SERVICE BULLETIN # 78

TRANSIT DRUM BALANCING METHOD

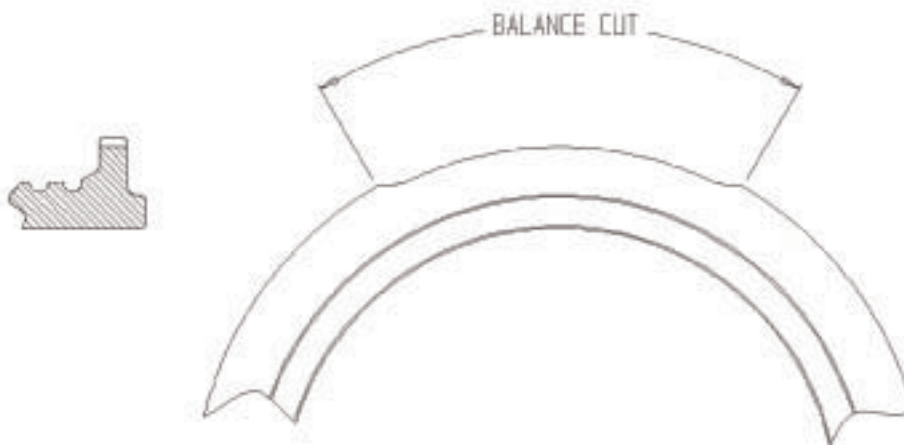
The purpose of this bulletin is to notify all customers who buy or use transit bus brake drums that our method of balancing will be changing. Currently we balance all transit brake drums through the use of welded weights. The new method of balancing will be to balance these drums by removing metal from the outside of the band diameter as shown below.

This change will be phased in over the next six (6) months starting July 5, 2003. This change will enable us to balance transit bus drums more efficiently and to improve this product by eliminating the welding of steel weights to the outside of the drum.
